ADDENDUM NO. 2

DATED: SEPTEMBER 30, 2026

PROJECT: **REBID**
New Fleet Management Building for AIDT
Montgomery, Alabama

PH&J No: 2502-CUA

RE-BID
C2.0
ADDENDUM #2
ATTACHMENT #2
© PH&J ARCHITECTS, INC.
ALL RIGHTS RESERVED

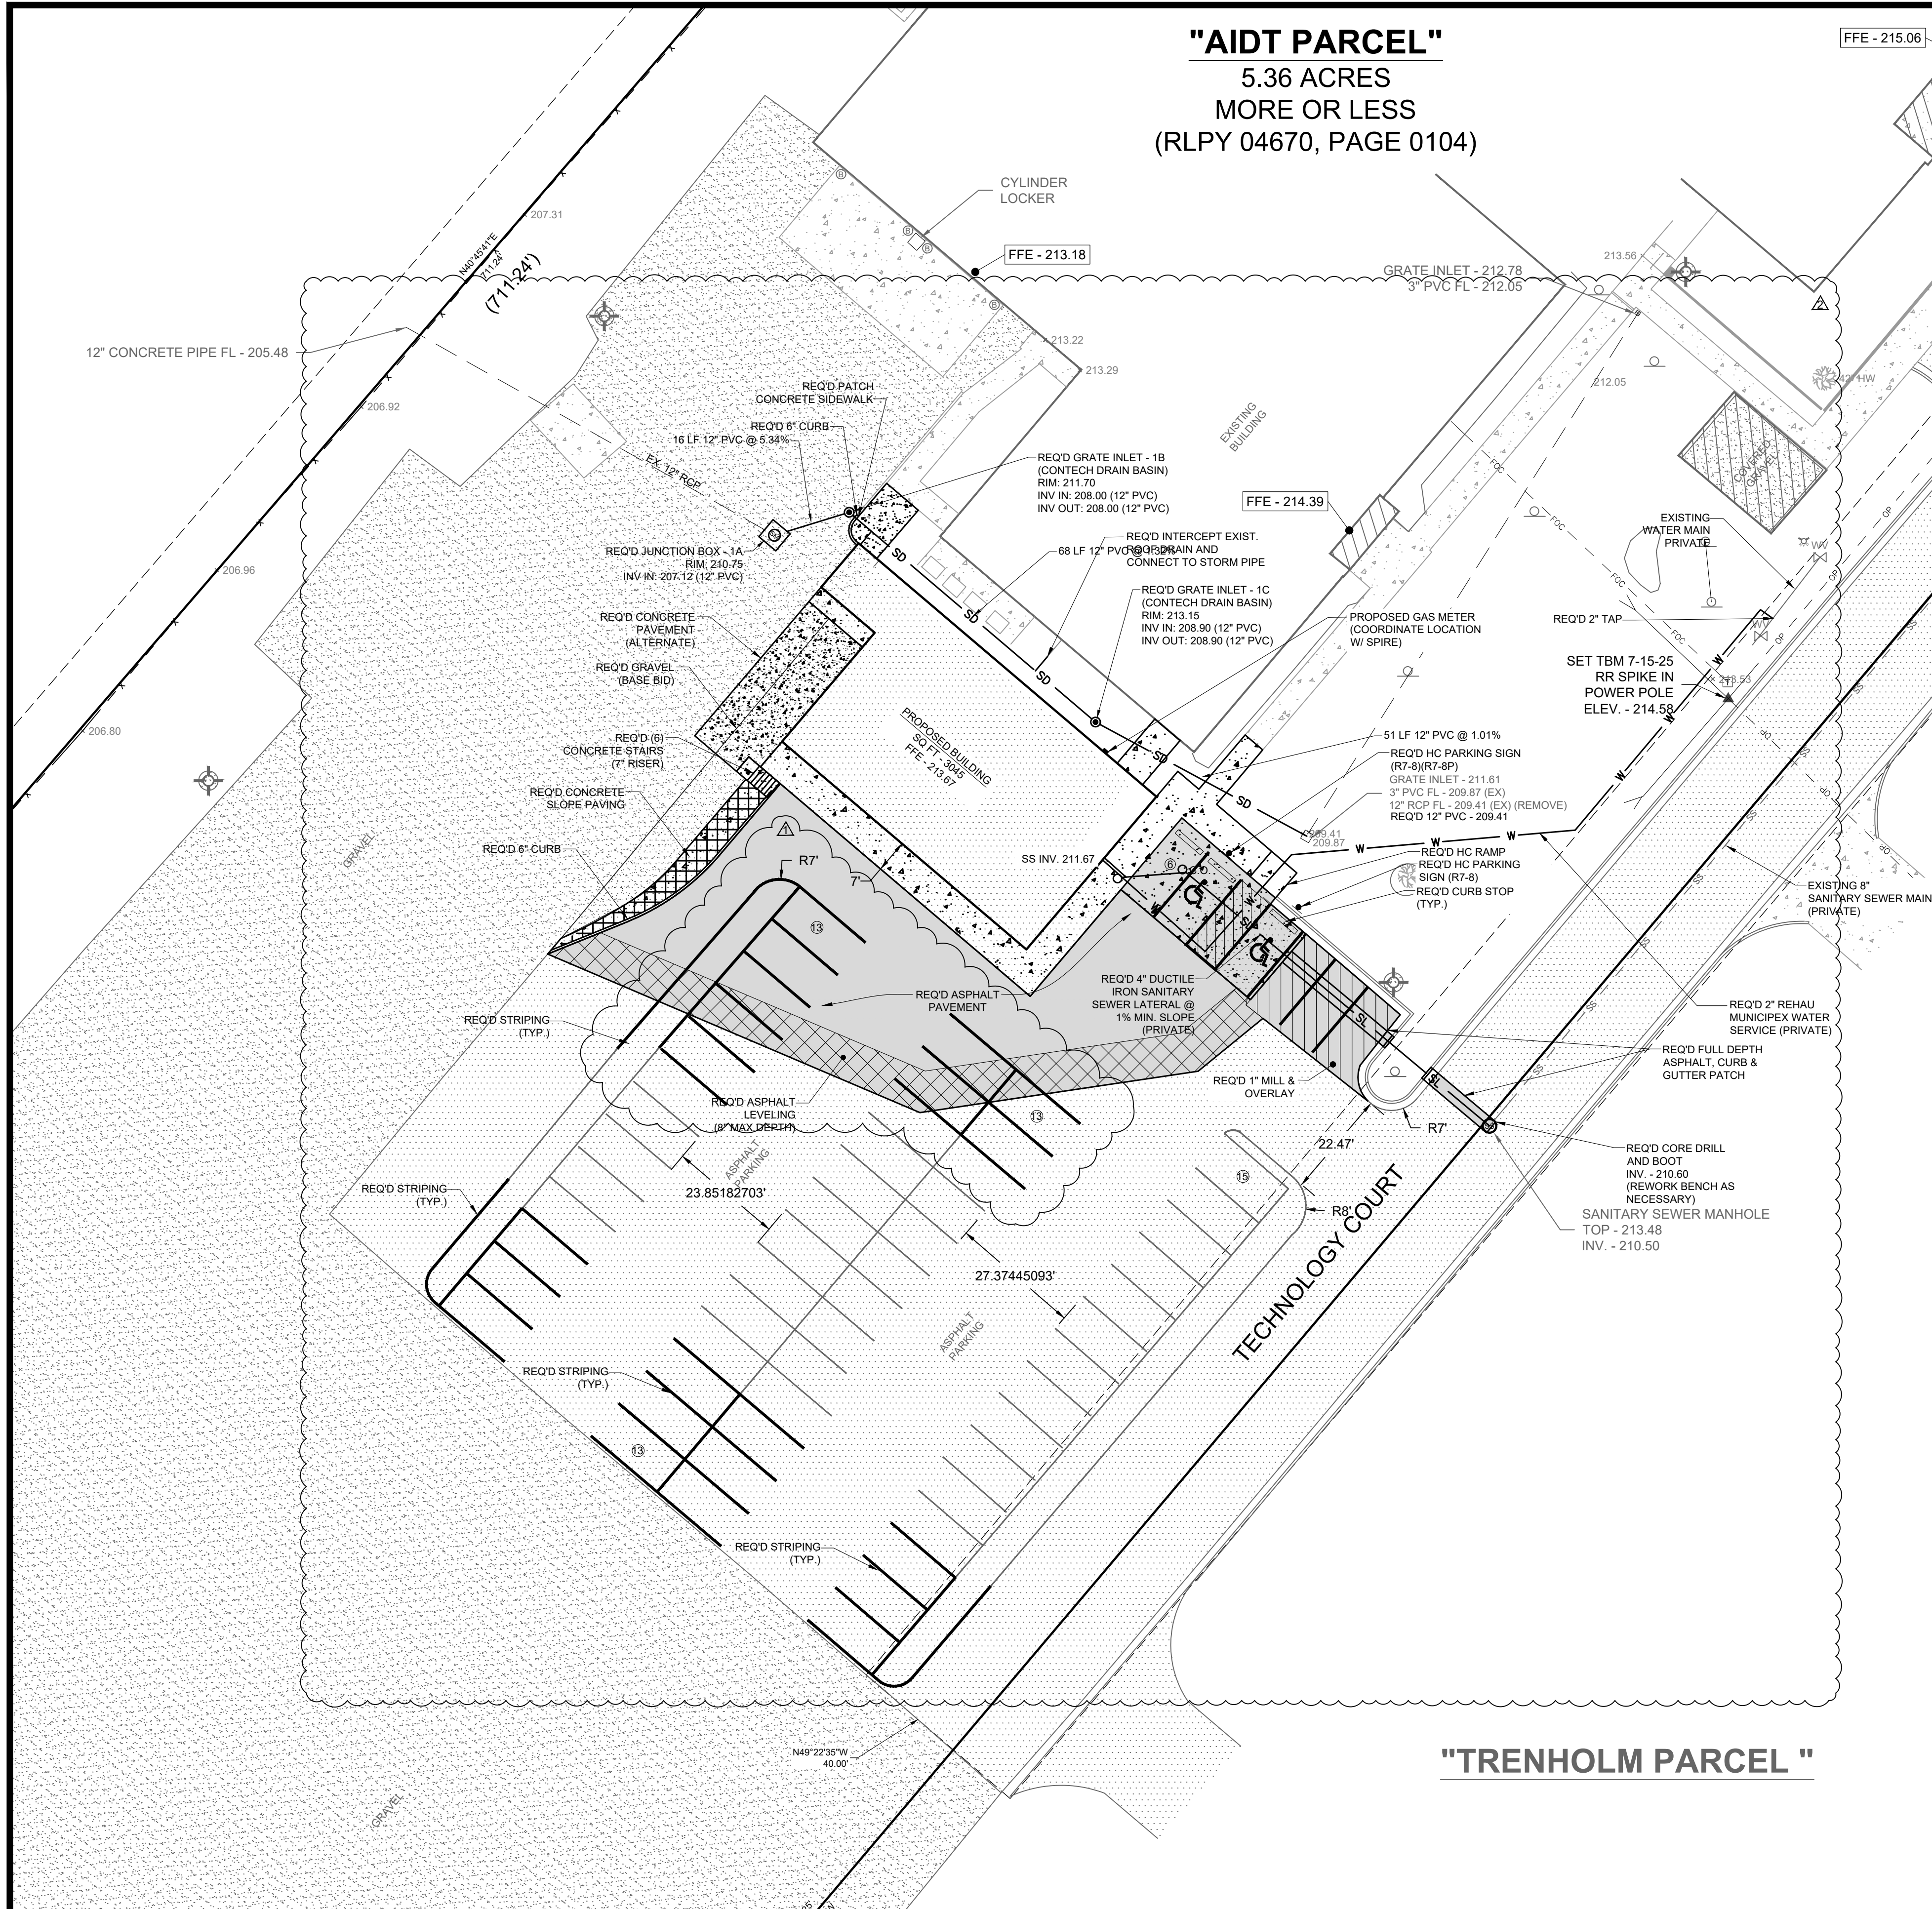
2. **Overall Grading Plan** (Sht. C2.0): See **Attachment #2** for adjusted grading as effected by increased sidewalk widths.
3. **Floor Plan** (Sht. 2.0): See **Attachment #3** for increased sidewalk widths, Office #104 (Alternate #2) door relocation, removed lighting pole relocation, increased Alternate #1 slab size and other items effected by sidewalk width.

C1.0

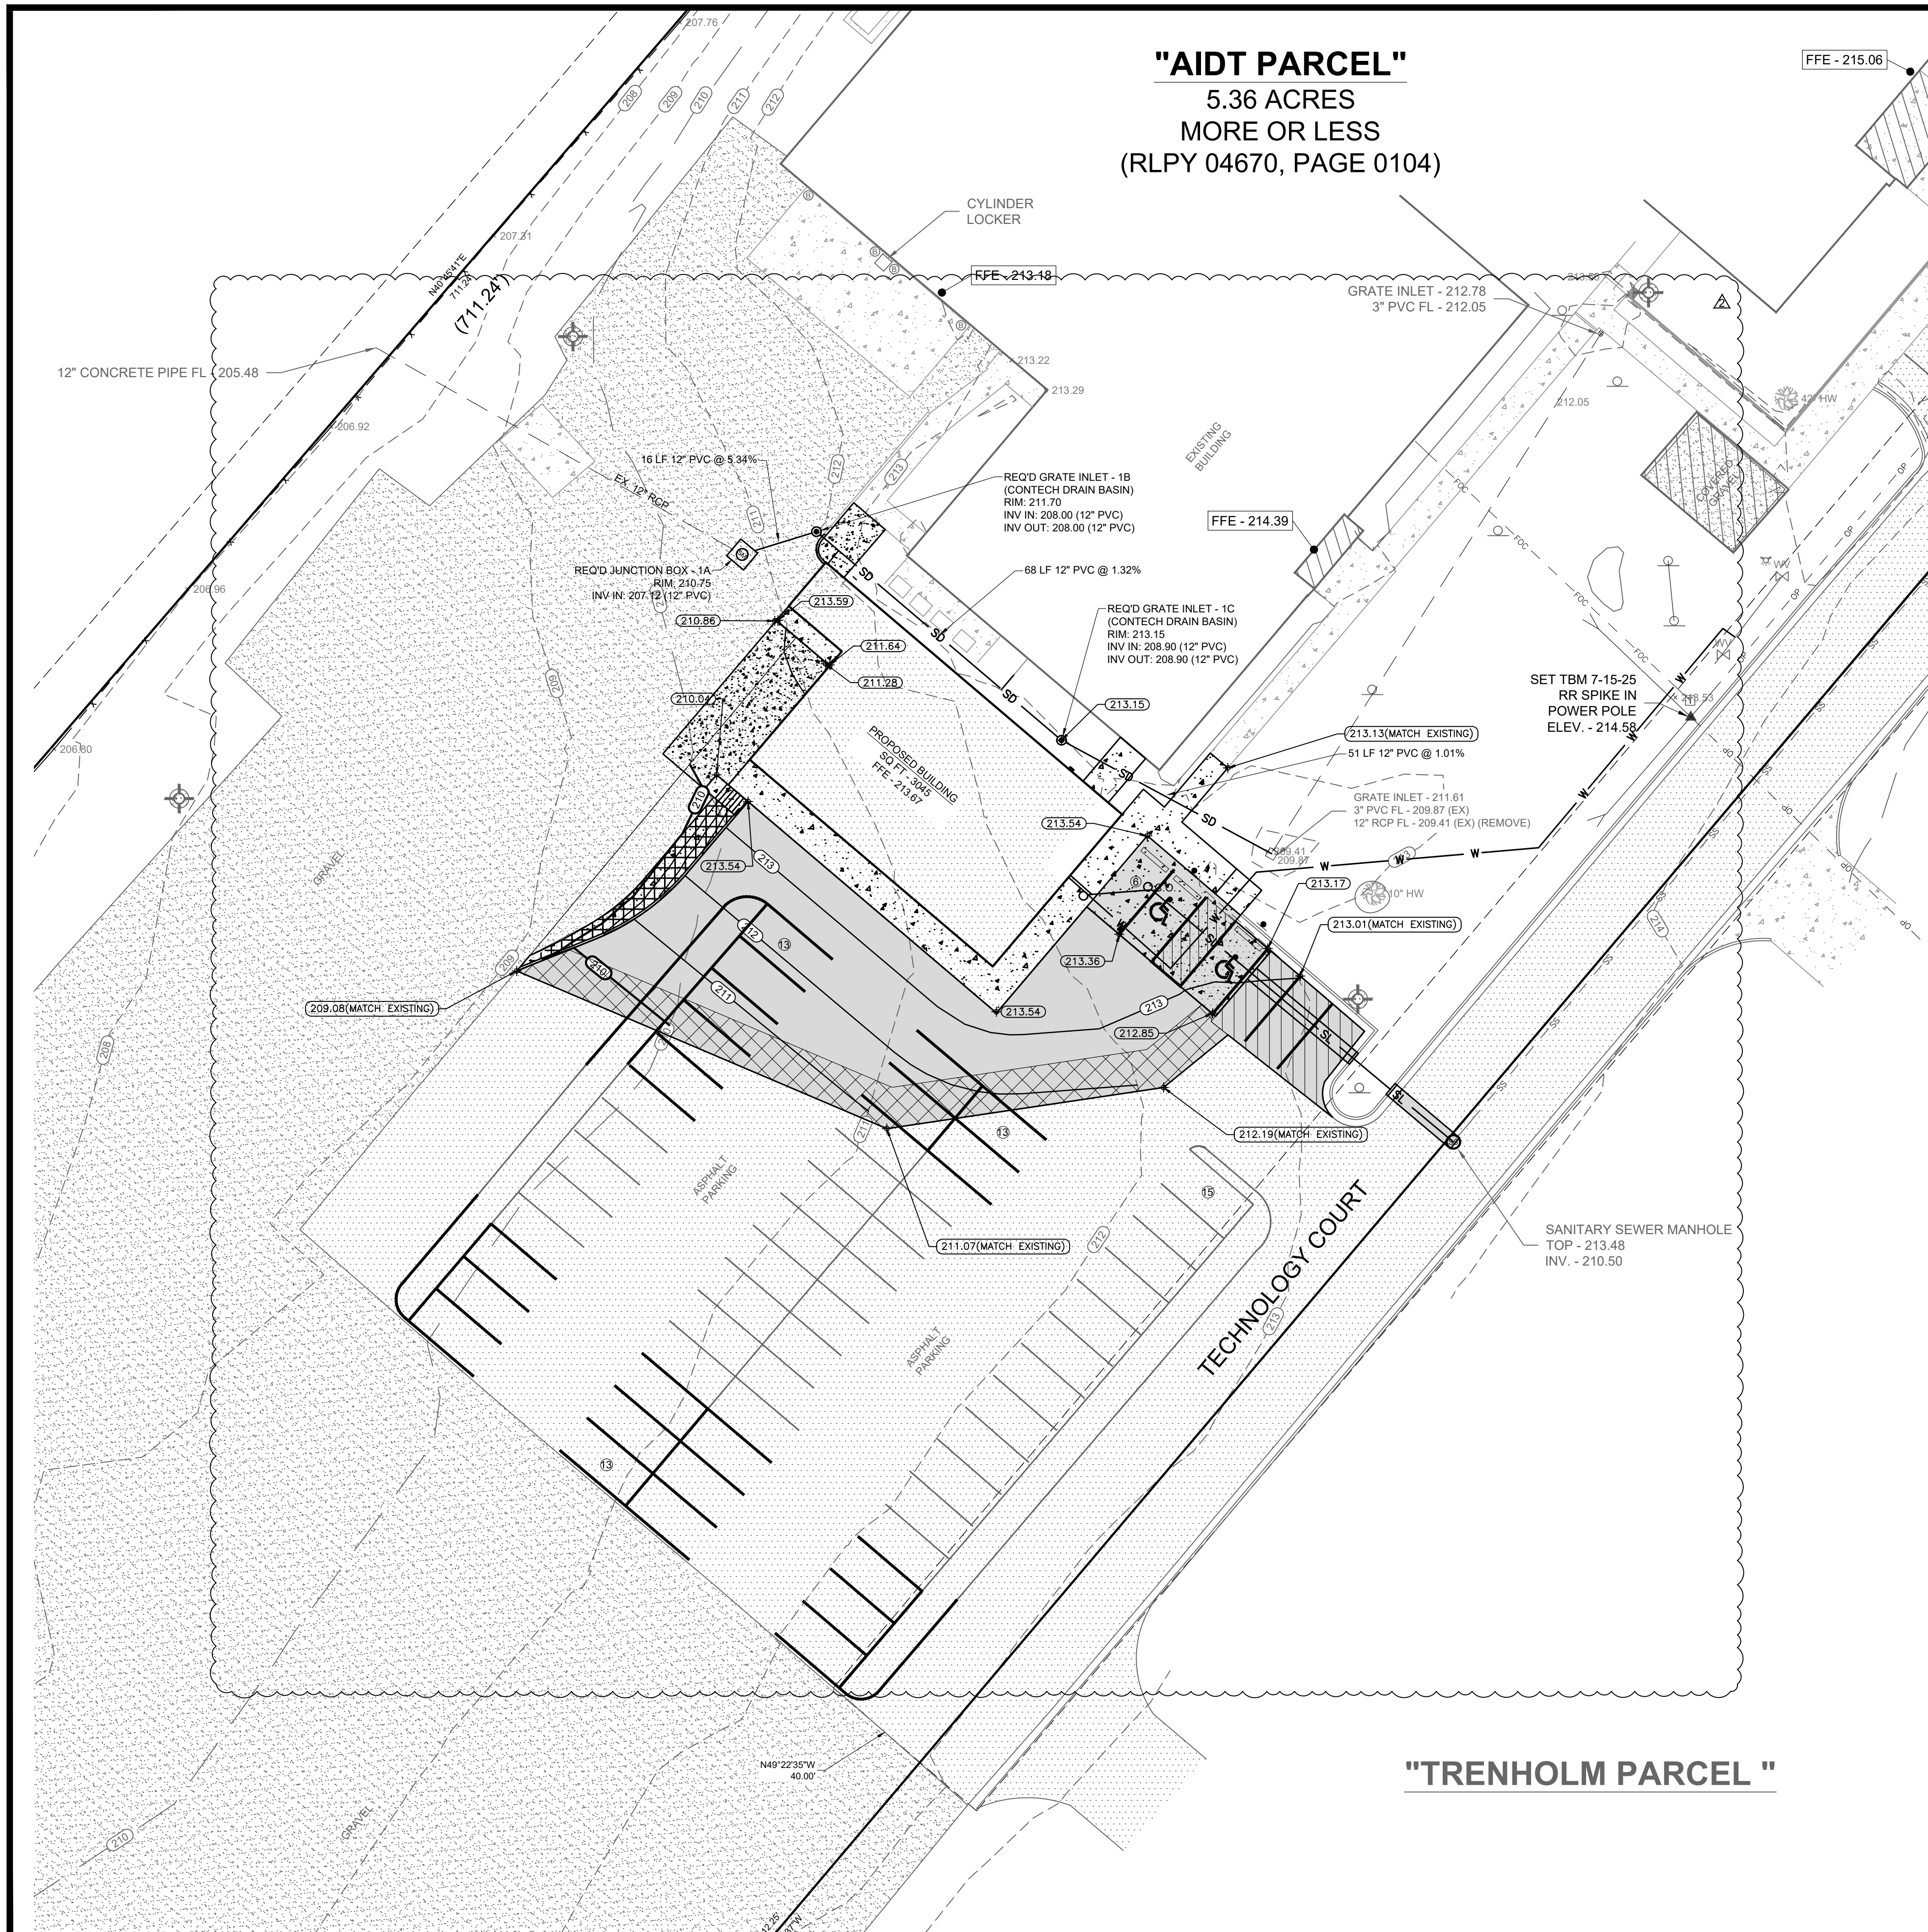
1. **Overall Site Plan** (Sht. C1.0): See **Attachment #1** for increased sidewalk widths and deletion of asphalt paving on southwest end of parking lot.

BASE BID SITE PLAN - ELECTRICAL
SCALE: 1" = 30'-0"

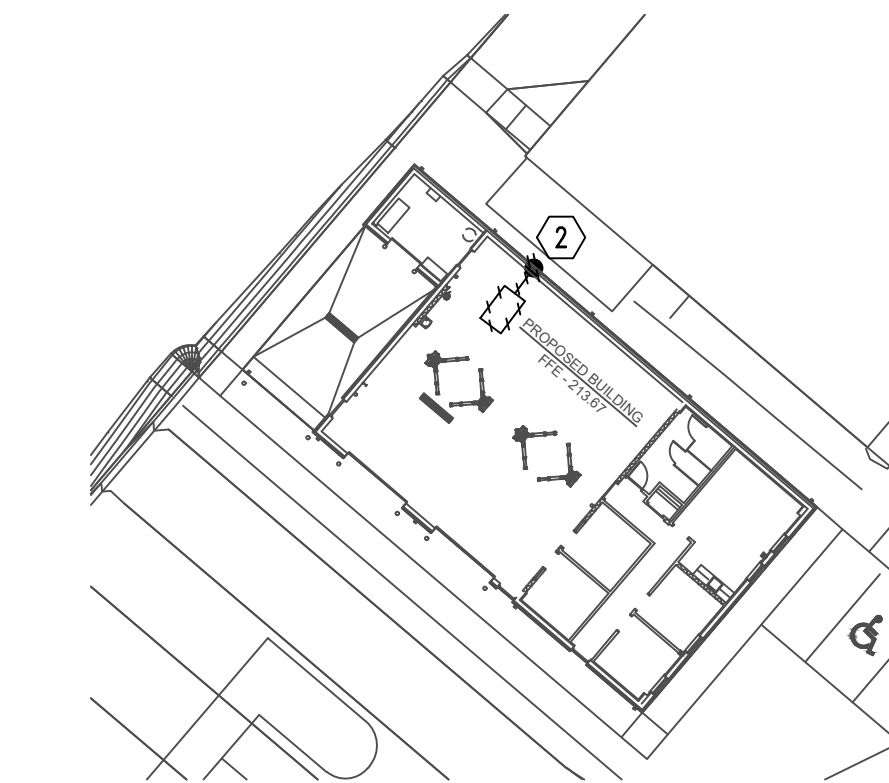
1. **Base Bid Electrical Site Plan** (Sht. E1.1): See **Attachment #4** for relocation of exterior 50 amp RV connection.
2. **Lighting Plan** (Sht. E2.1): See **Attachment #5** for relocation of pole light, deletion of exterior light on northwest end of Storage #111 and deletion of sheet note #5.

RE-BID
E2.1

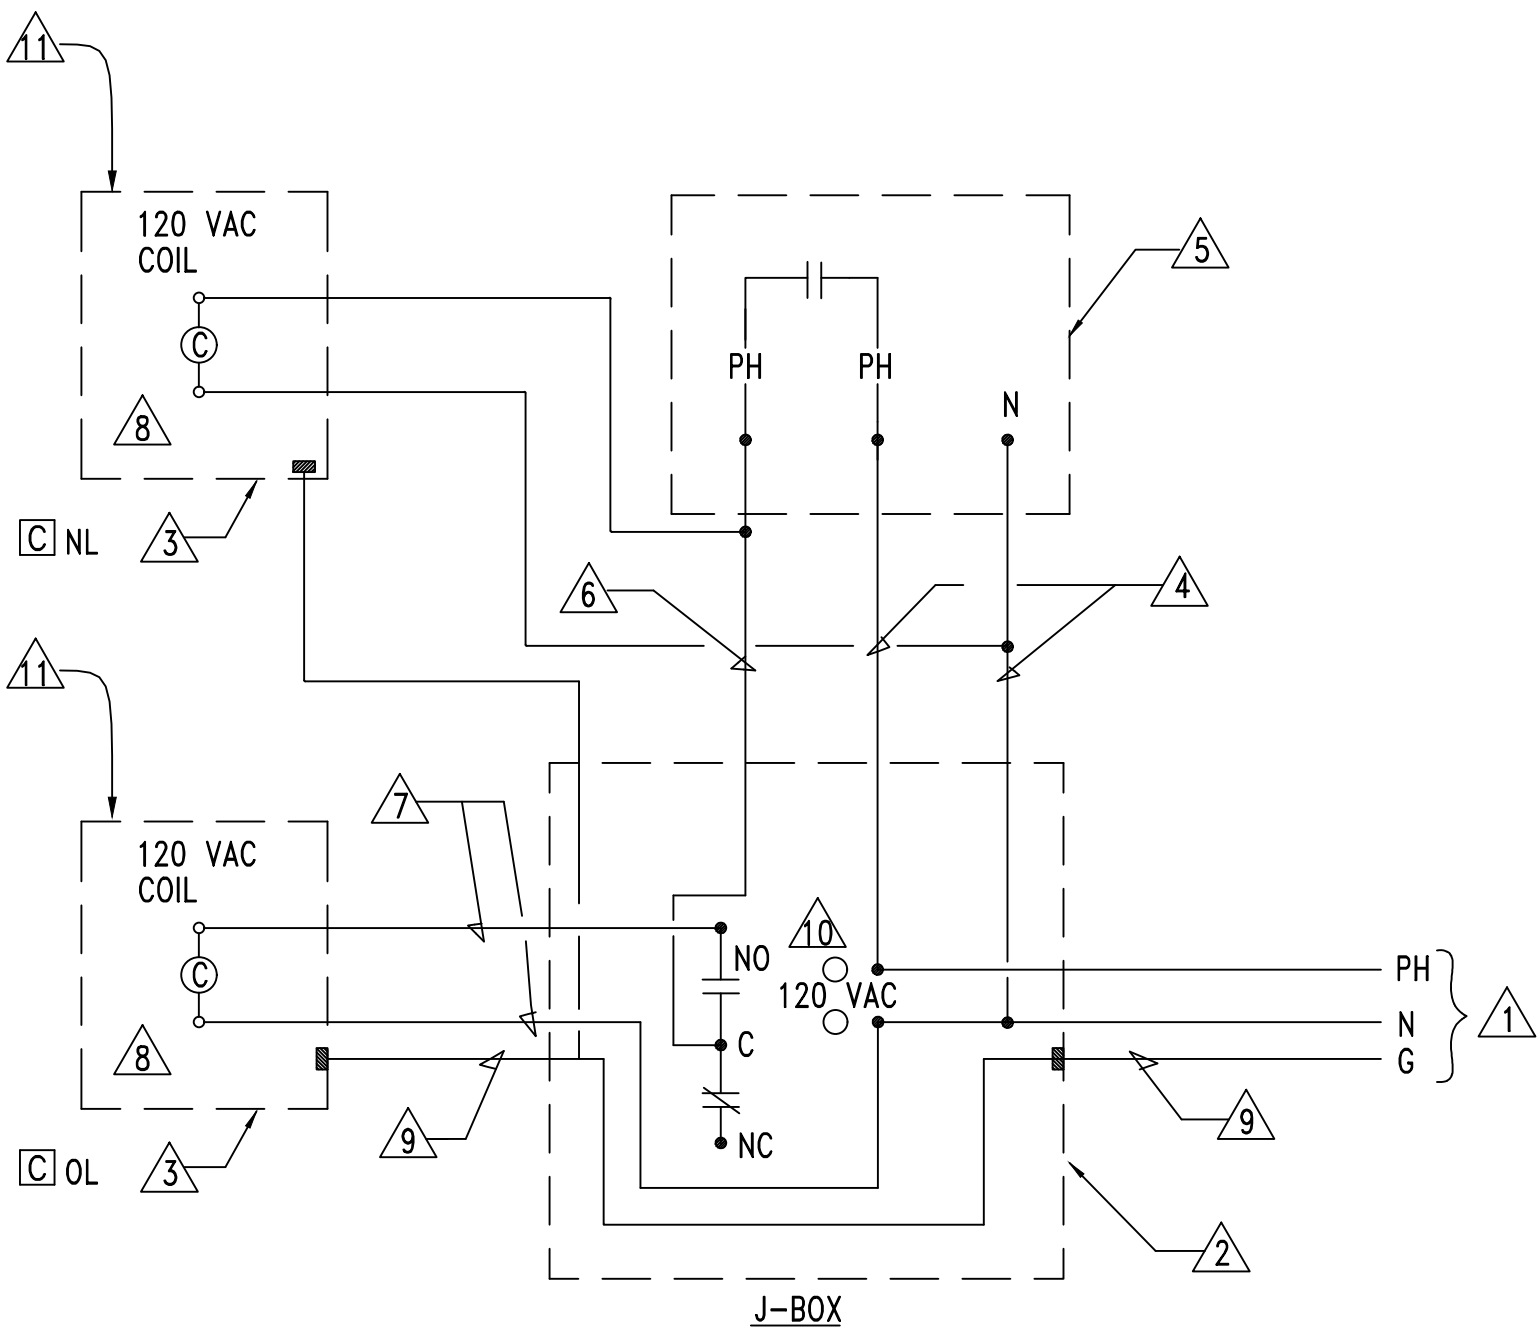
- ⑥ EXISTING LIGHT POLE TO BE REMOVED & RELOCATED. CONTRACTOR SHALL INTERCEPT & EXTEND EXISTING CIRCUIT AS REQUIRED.
